ITEM FOR ENVIRONMENTAL COMMISSION AGENDA

Commission Meeting Date Requested:	February 6, 2019	
NAME & NUMBER OF Project:	West Harbour Marina SP-2018-0221C	
NAME OF APPLICANT OR ORGANIZATION:	G4 Interests LLC 979-412-0324	
LOCATION:	2503 Westlake Dr., Austin, TX 78745	
COUNCIL DISTRICT:	District 10	
PROJECT FILING DATE:	June 15, 2018	
DSD/Environmental Staff:	Pamela Abee-Taulli Environmental Review Specialist Senior 512-974-1879, <u>pamela.abee-taulli@austintexas.gov</u>	
WPD/ERM STAFF	Not applicable for this variance.	
WATERSHED:	Lake Austin Watershed Water Supply Rural classification Drinking Water Protection Zone	
ORDINANCE:	Watershed Protection Ordinance (current code)	
REQUEST:	Variance request is as follows:1. Request to vary from 25-8-368(E) to allow more than 25 cubic yards of dredging in Lake Austin.	
STAFF	Staff determination is that the findings of fact have been met.	
DETERMINATION:	Staff recommends the following conditions: 1) install cofferdams before beginning dredging on the 4 slips adjacent to Heritage tree roots; 2) provide additional mitigation, beyond the requirements, for wetlands (32 additional plants), riparian restoration (7 additional 609S plants), and tree

- 1. Cofferdam Locations for Heritage Tree Protection p. 6
- 2. Table of Required and Proposed Mitigation Plantings p. 7

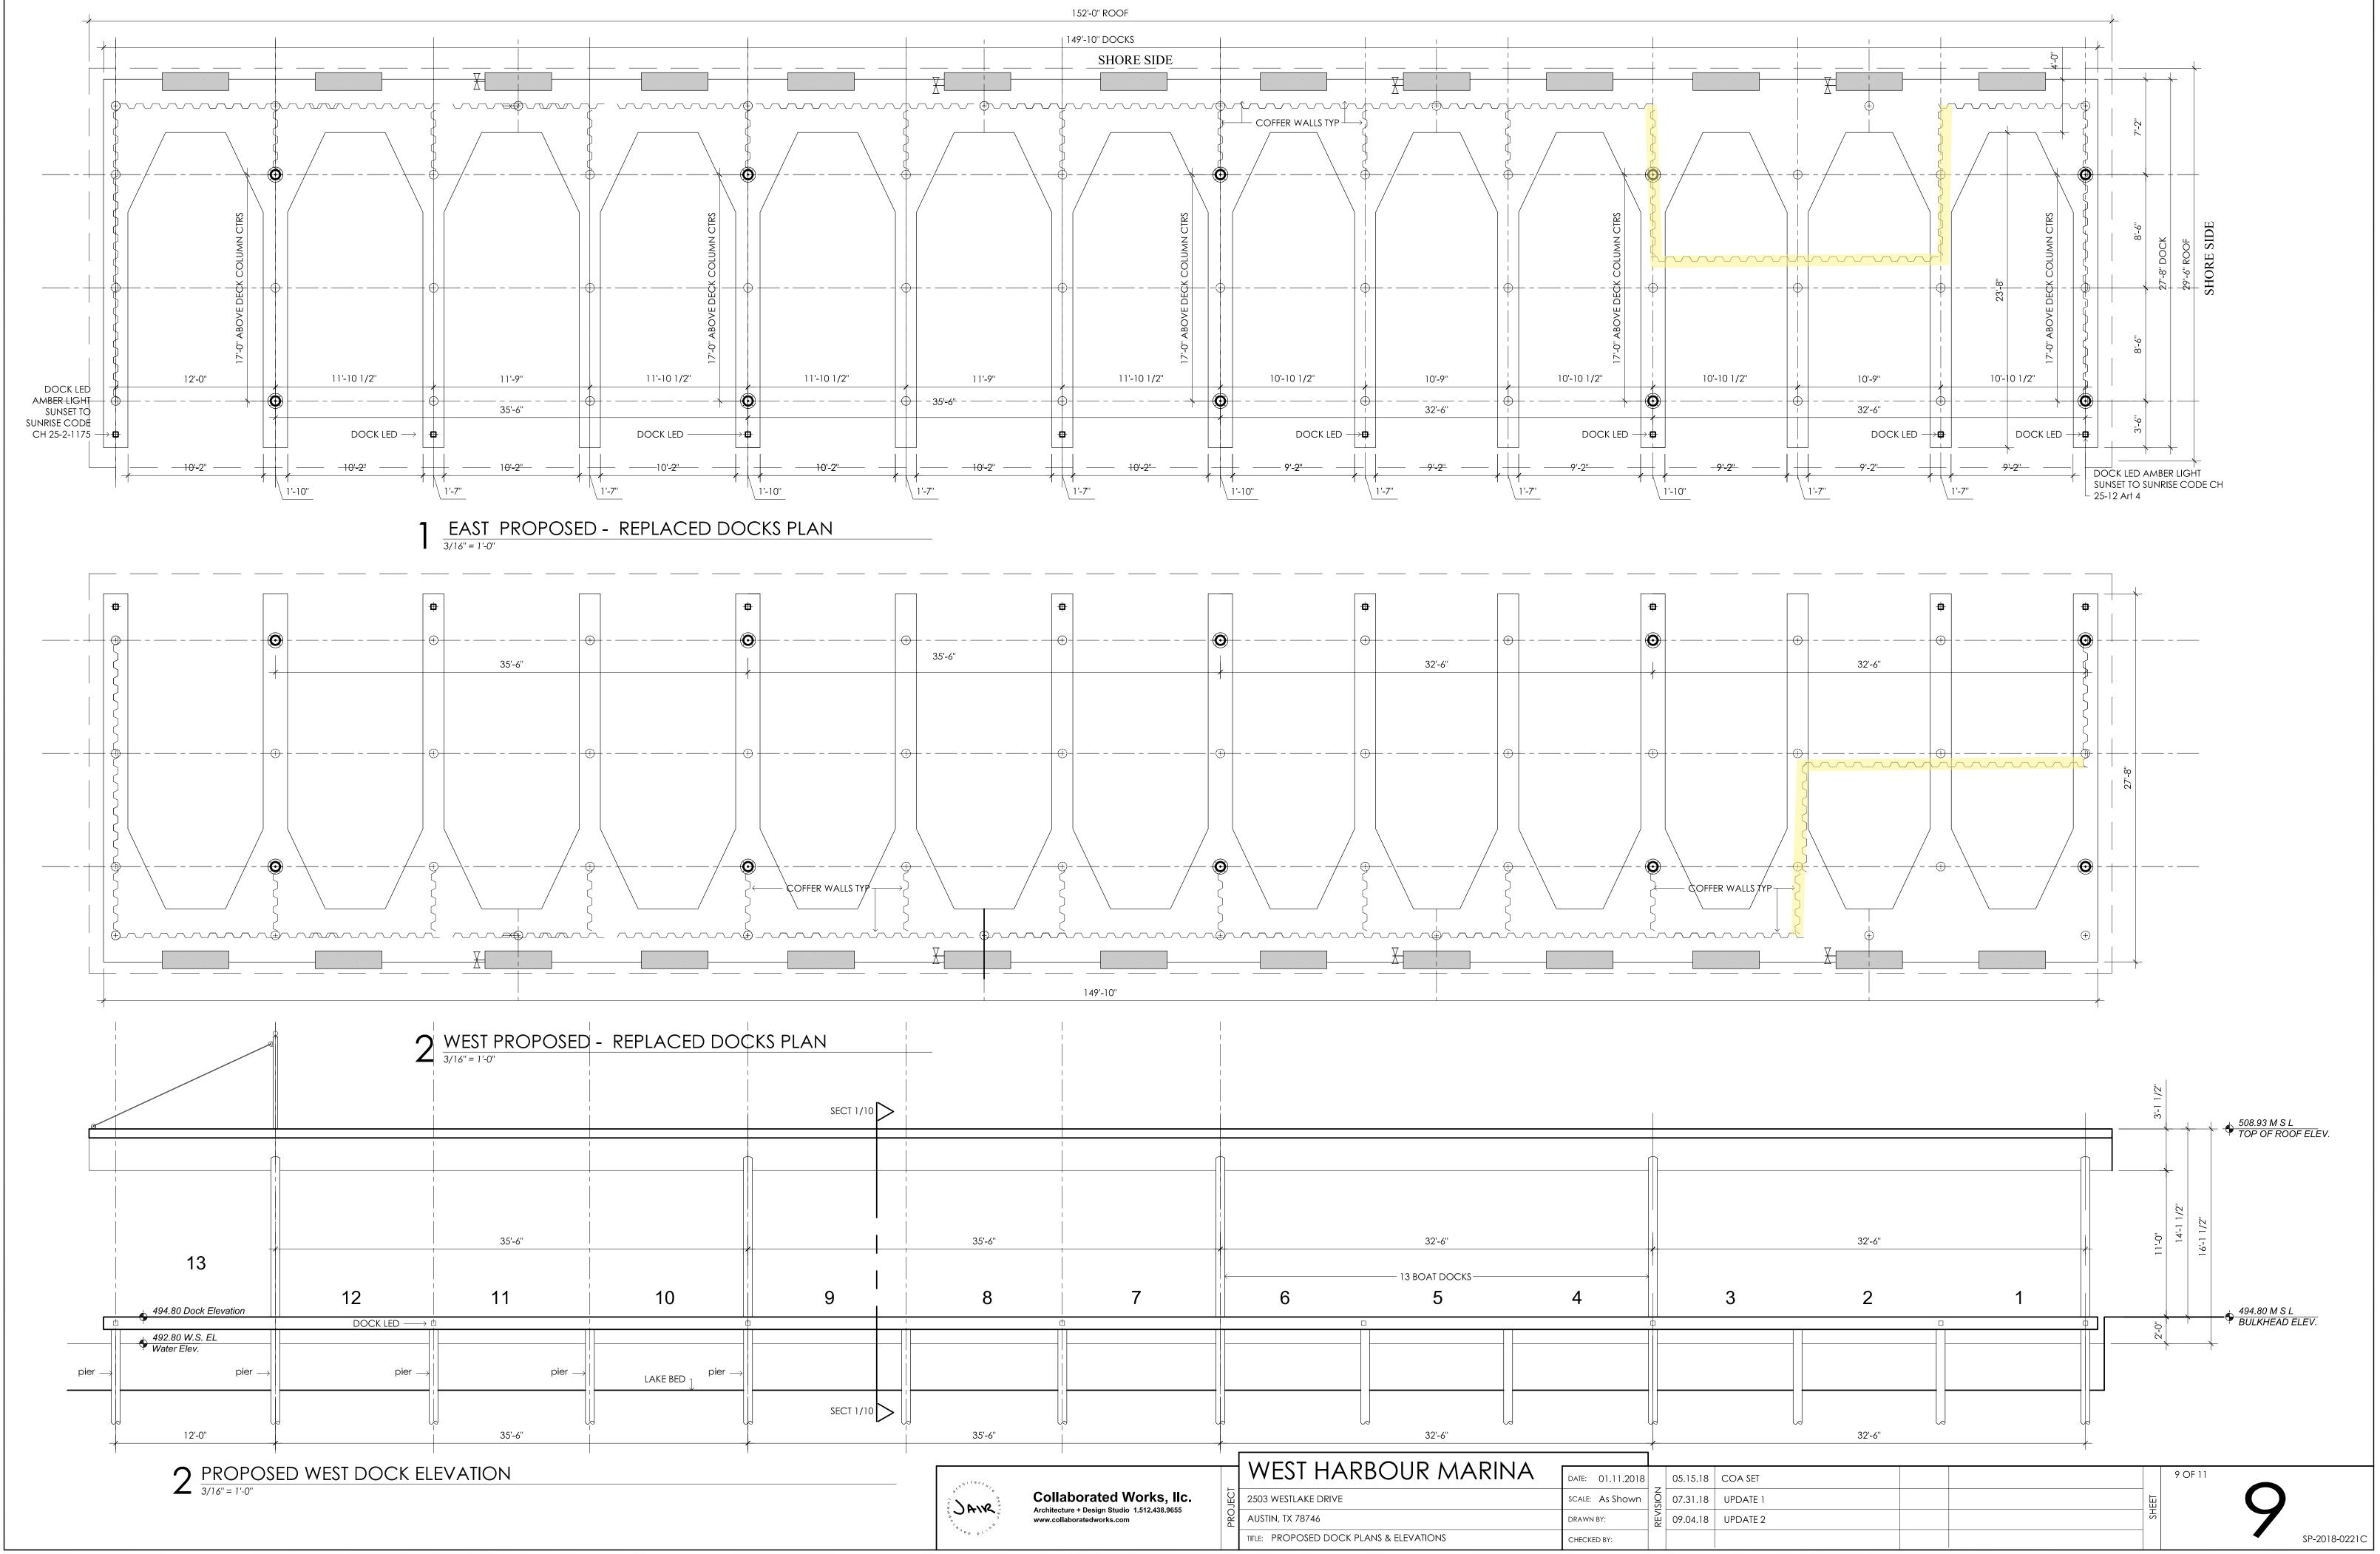
Staff determination is that the findings of fact have been met. Staff recommends the following conditions: 1) install cofferdams

before beginning dredging on the 4 slips adjacent to Heritage tree roots; 2) provide additional mitigation, beyond the requirements, for wetlands (32 additional plants), riparian restoration (7 additional 609S plants), and tree replacement (32 additional inches).
